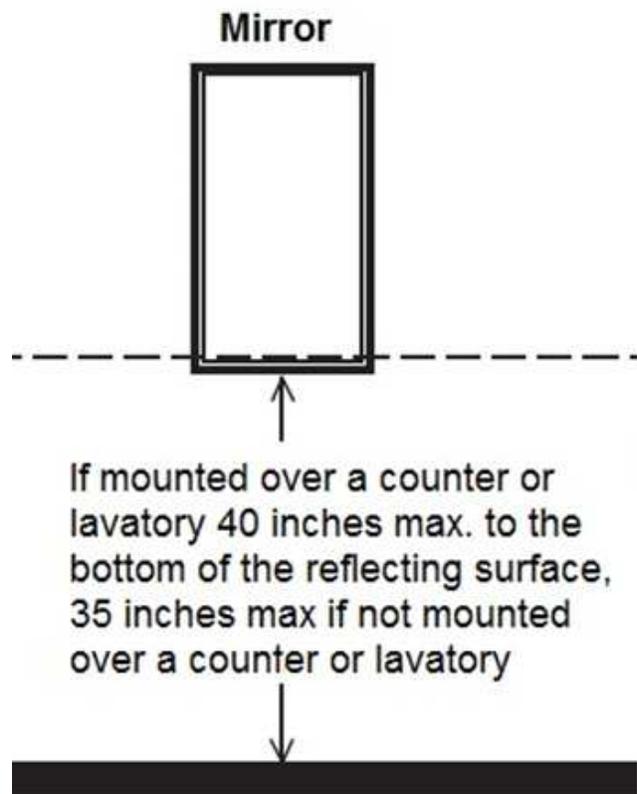
The mirror is mounted too high.
